Summary of Comments on Microsoft Word - 100.063-fdr

CORE ENGINEERING GROUP		Standard Form SF-2, Storm Drainage System Design (Rational Method Procedure)																						
Calculated By: Leonard Beasley		Job No: 100.063																						
Date: Nov. 4, 2020		Project: Skyline at Lorson Ranch																						
Checked By: Leonard Beasley		Design Storm: 5 - Year Event (Proposed)																						
Street or Basin	Design Point	Direct Runoff						Total Runoff						Street				Pipe				Travel Time		Remarks
		Area (A)	Runoff Coeff. (C)	I _a	Q	I _t	Q	Σ (I _a)	I _t	Q	Slope	Street Flow	Design Flow	Slope	Pipe Size	Length	Velocity	Time						
																			ac.	min.	in/hr	cfs	min	
C5.1-ex		4.81	0.11	21.6	0.53	2.97	1.6																	
C10.7		3.17	0.45	13.5	1.42	3.68	5.3																	
C10.7 & C5.1-ex	38	7.98						15.6	1.96	3.46	6.8													
C10.8		1.89	0.45	12.5	0.85	3.80	3.2																	
C10.7, C10.8 & C5.1-ex		9.87						20.6	2.81	3.05	14.5

Storm Sewer Summary Report

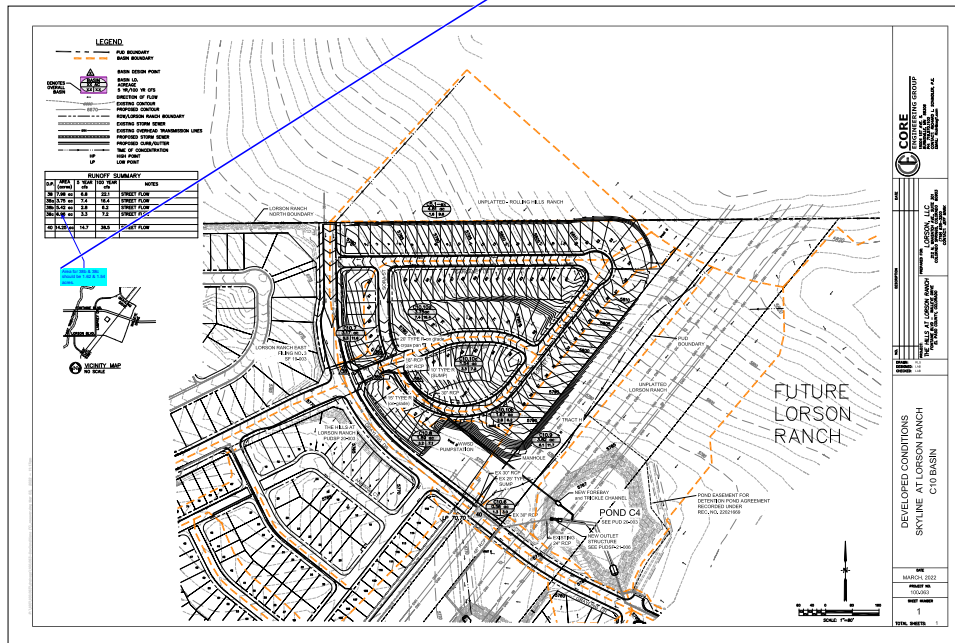
Update storm sewer design to match information in CD's - Lengths and inverts in storm sewer model do not match those shown in construction drawings. Please revise accordingly so documents match.

Pipe lengths and inverts do not match storm model data. Please revise accordingly so model and construction drawings match.

model updated
